C	05.11.24	RBL	Issued for Planning - amendments as annotated
B	08.07.24	RBL	Issued for Planning - note re cellular system amended
A	21.11.23	RBL	Issued for Planning - FFLs and note re soil volume added
-	01.11.23	RBL	Issued for Planning

client / project
Reading Borough Council
Amethyst Lane

drawing title
Soil Plan

drawing number	revision
RBC-ALR HTA-L DR 0901	C
scale @ A1	project code
1:200	RBL
HTA Design LLP	RBC-ALR
www.hta.co.uk

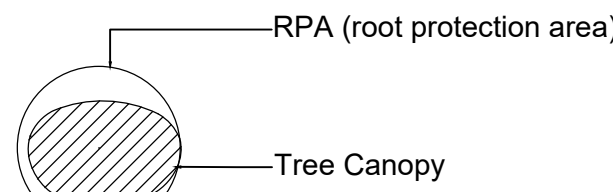
Rev C: G3 to north to be cut back to allow construction of new boundary fence and managed as a high hedge (refer to Arboricultural Method Statement).

Rev C: Soil cells relocated to avoid service routes

Rev C: note re soil volume amended

Rev C: Root barrier extents amended to take account of foul sewer
